STAFF REPORT
CITY OF BEVERLY HILLS

**For the Planning
Commission Meeting of
July 8, 2010**

SUBJECT: Development Plan Review and a Variance Application to allow tandem parking for construction of a new three-story, 45-foot tall Medical/General Office building containing approximately 40,750 square feet of floor area over a four-level, subterranean parking garage with 185 parking spaces at **119-123 San Vicente Boulevard**. A Mitigated Negative Declaration has been prepared for the Project

Continued from the meeting of May 27, 2010.

PRELIMINARY DRAWING

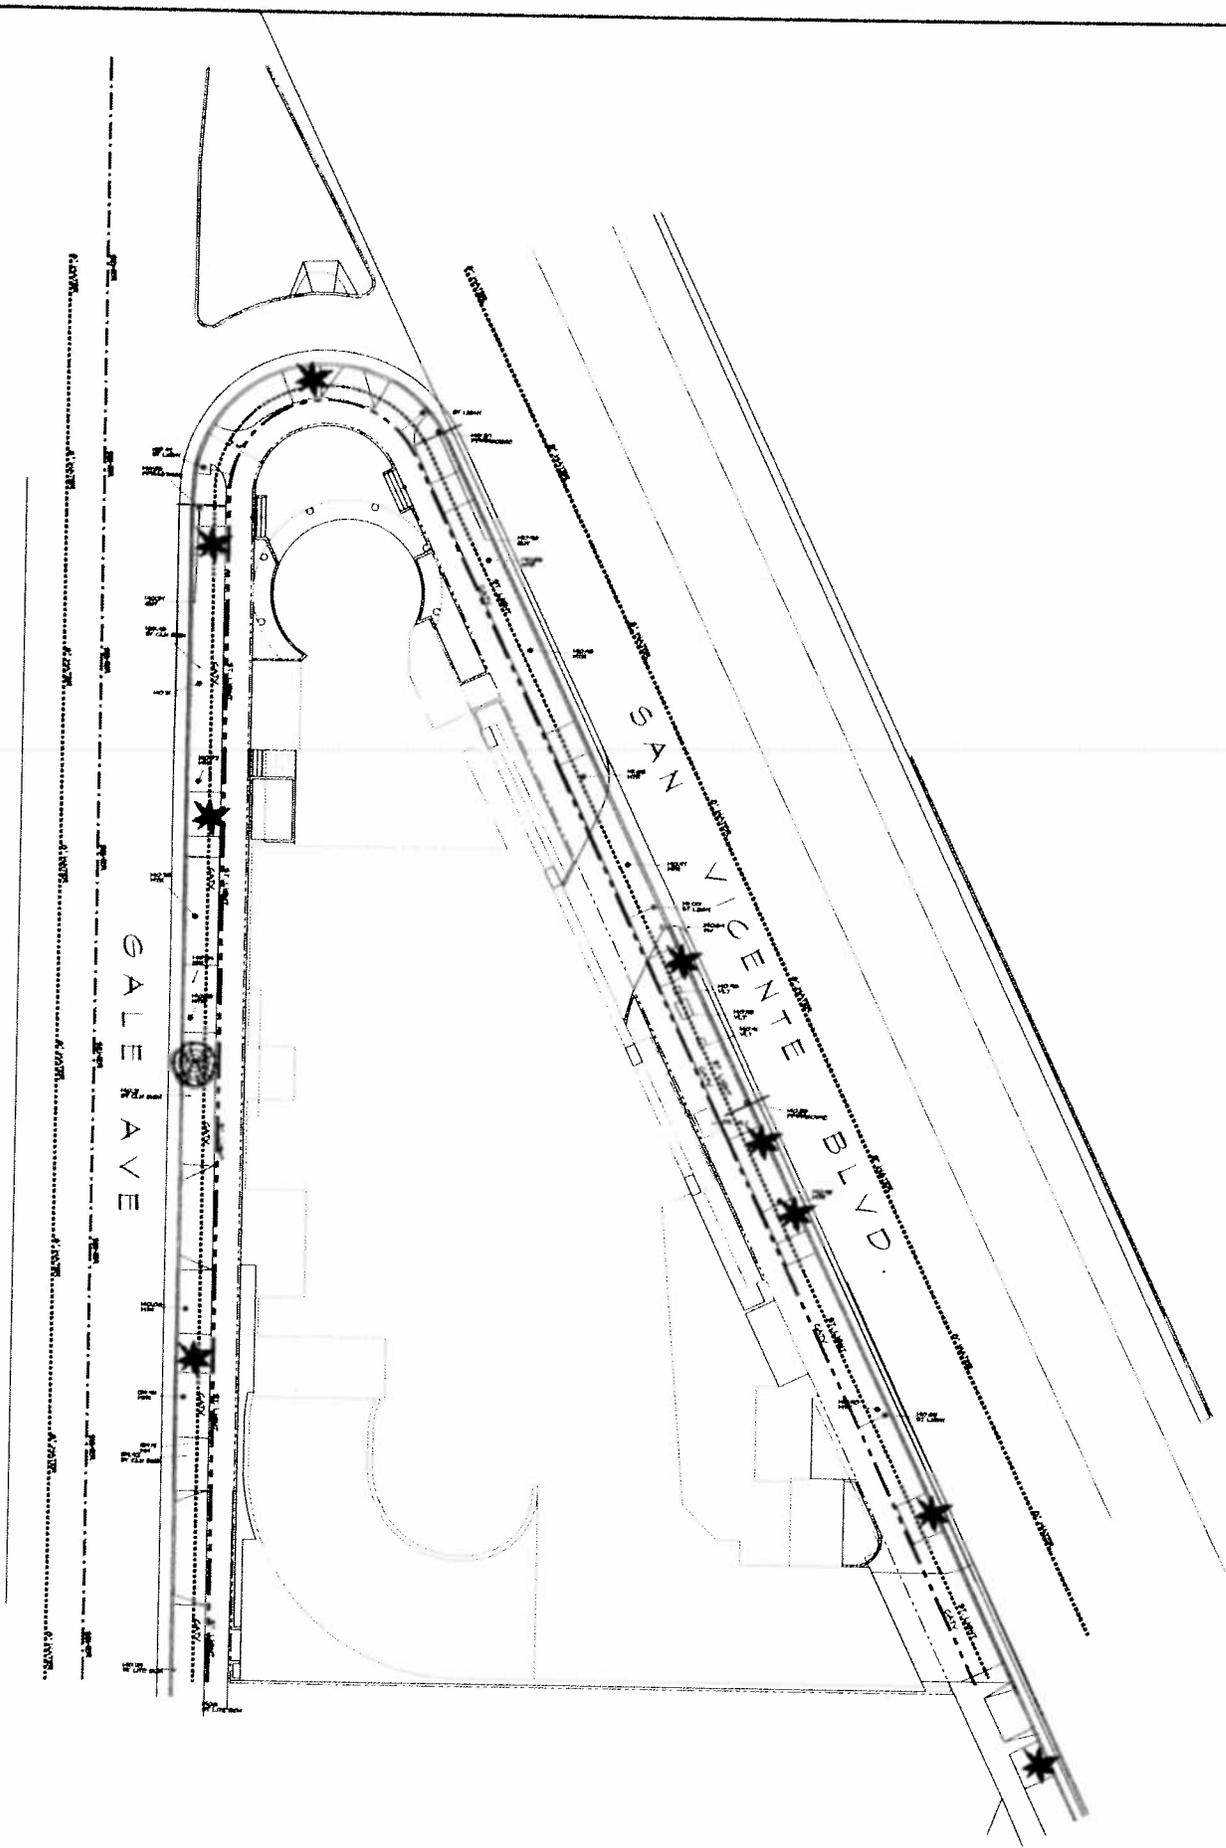
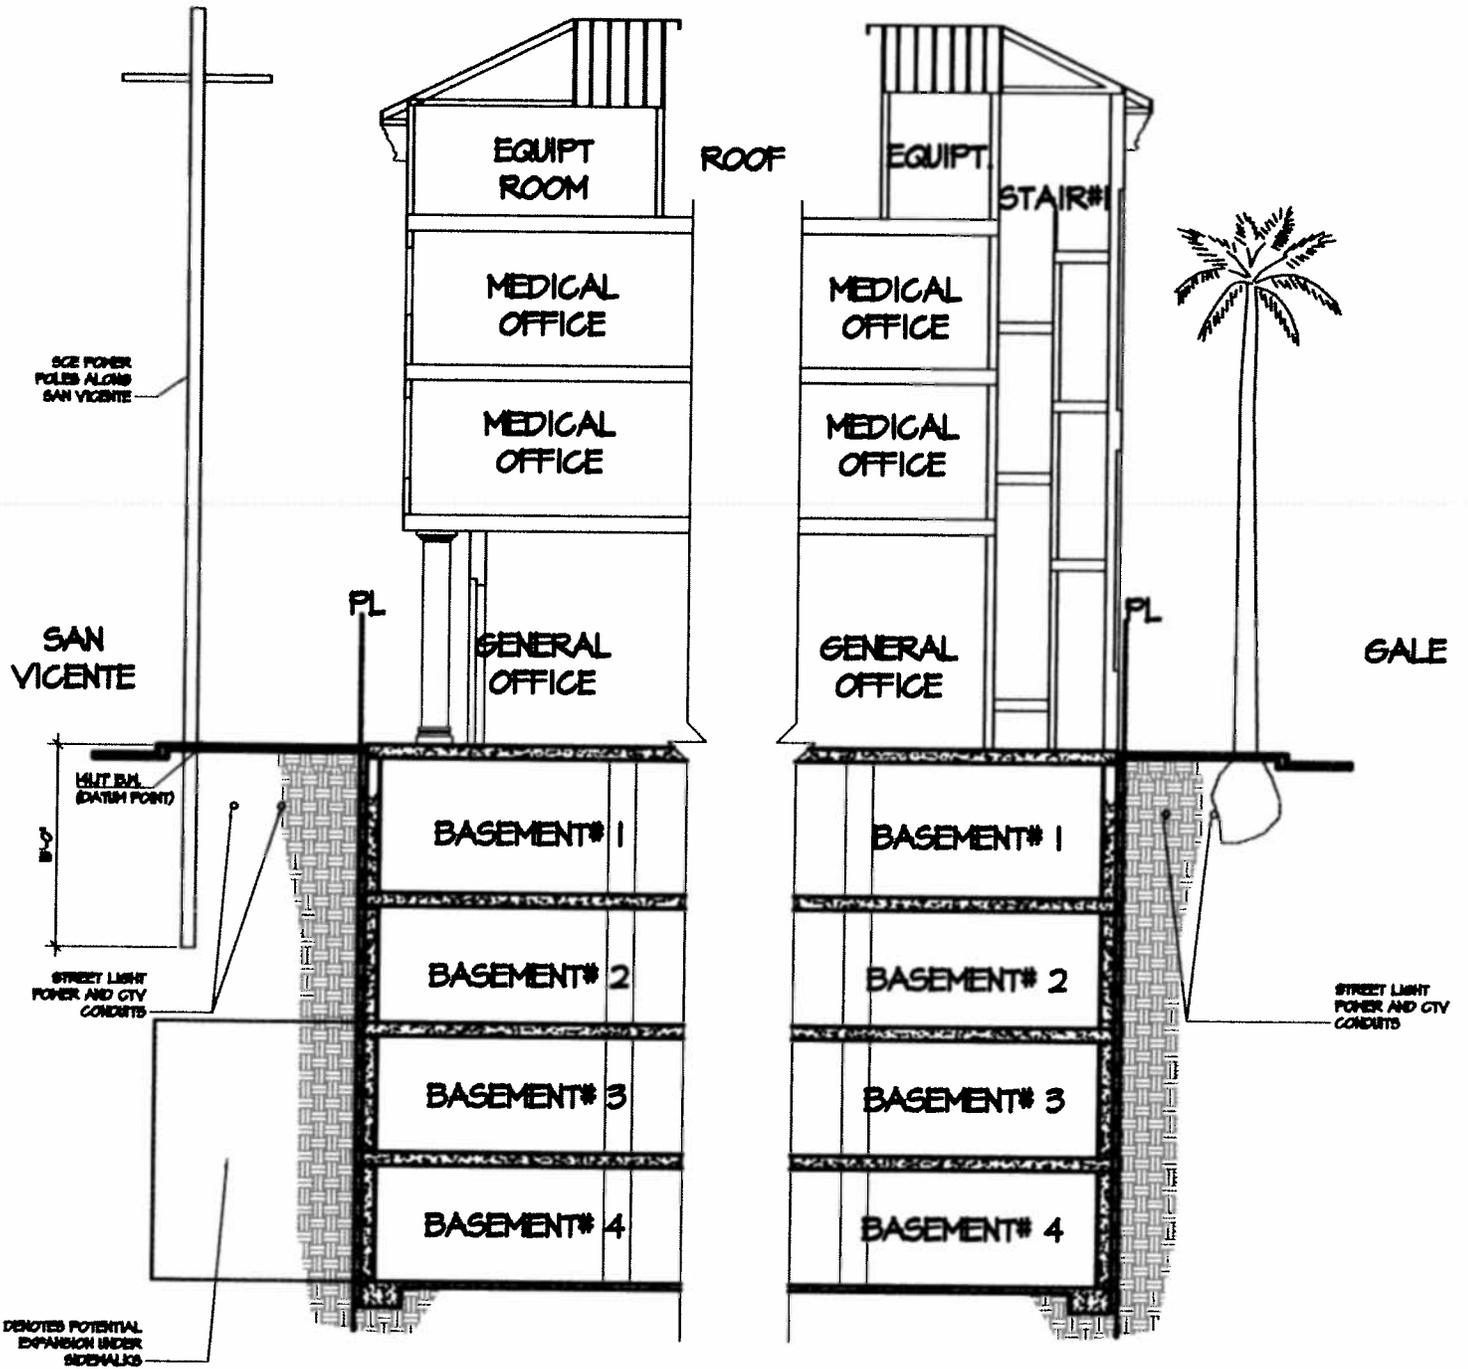
At the Planning Commission meeting of May 27, 2010, The Commissioners requested that Applicant consider expanding the underground parking for the Project by securing from the City the necessary underground encroachment easements under the sidewalks, along both San Vicente Blvd. and North Gale Drive, and building parking areas within these easements. The Applicant reviewed the matter with City staff and the City Engineer and also investigated the matter on its own. The conclusion was this concept is not feasible.

There are several reasons for the conclusion this concept is not feasible. From an investigation of these sidewalk areas, it was determined that there were major utilities easements that either can not be moved or would be cost prohibitive to be moved. Attached to this memorandum is an exhibit (diagram) showing the location of the utilities that are currently in place under these sidewalks. It should be noted that the Southern California Edison ("SCE") easement along San Vicente is not just for ordinary lighting but is a high voltage transmission line that now is located above grade on power poles along with the on grade switching equipment. SCE has advised the City and the Applicant that they intend to place these transmission lines below grade, under the sidewalk, along San Vicente Blvd.

Even if the utility companies were to agree to allow the encroachment of the building into the sidewalk areas for the underground parking, the cost of moving or relocating the utility lines would be cost prohibitive for the Applicant. Also, the first 2 floor levels along the San Vicente side of the property could not be built under the sidewalk because of these utilities and structures. The 55 foot high SCE power poles are set 15 feet into the ground; the existing Palm Trees (street trees) are approximately 6 feet deep with their root base; and the City street lights and conduits for them are approximately 4 feet deep all along the San Vicente. Thus this concept would only provide additional space for parking on the 3rd and 4th level of the garages on the San Vicente side of the building.

Building under the sidewalks would not eliminate the need for tandem parking for the Project, whether the project was entirely all General Office space or a combination of Medical Office and General Office space. It is Applicant's contention that the revised plan addresses the concerns expressed at the last Planning Commission meeting as to the functionality of the parking arrangements without any need to expand the underground parking under the sidewalks.
